Kansas Department of Agriculture
 Division of Water Resources
CHANGE: P/D WORKSHEET

DWR FIELD OFFICE APPLICATION FOR APPROVAL TO CHANGE THE PLACE OF USE AND/OR THE POINT OF DIVERSION

RE: Application for Change in Point of Diversion
Water Right, File No. 45343

Evaluation of proposed move for Water Right No 45343

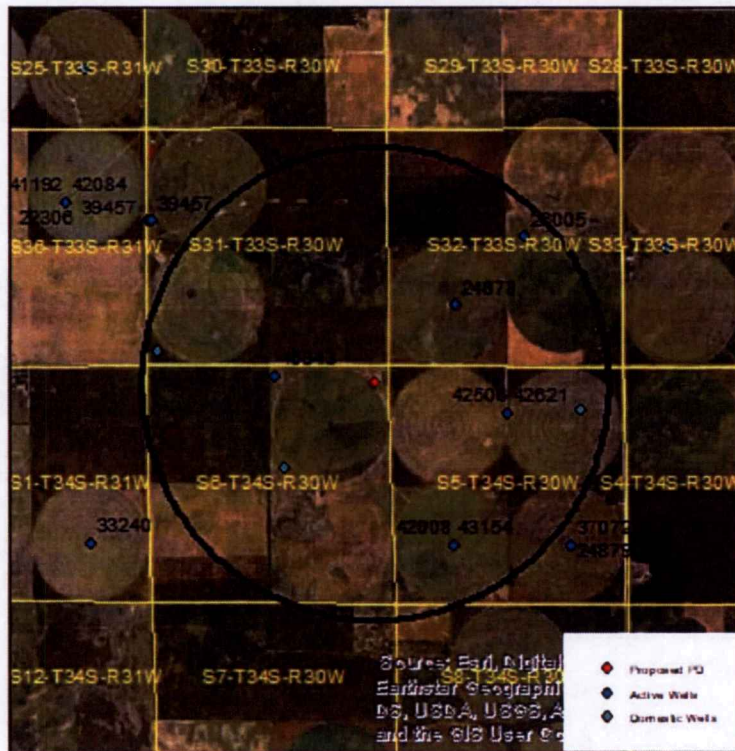
Proposed: Move water right no. 45343 a distance of 2,279 ft to the east.

Wells within 1 mile: 24878, 26005, 42506 & 42621, 42008 & 43154, a domestic well in section 31-33-30, a domestic well in section 6-34-30, and a domestic well in section 5-34-30.

The saturated thickness at the proposed well location is estimated to be 253 ft, based upon the GMD3 model. For saturated thickness greater than 200 ft, the drawdown allowance is 4.0 ft.

- 24878:
 - Drawdown from current location = 0.46 ft
 - Drawdown from proposed location = 1.25 ft
 - Net drawdown = **0.8 ft**
- 26005:
 - Drawdown from current location = 0.37 ft
 - Drawdown from proposed location = 0.88 ft
 - Net drawdown = **0.5 ft**

Net drawdown does not exceed the drawdown allowance of 4.0 ft for any well within 1 mile of the proposed location. Therefore, critical well analysis is not necessary.

The proposed move is likely to create minimal effects on neighboring wells and is unlikely to cause impairment. GMD3 staff recommends approval of this proposal.
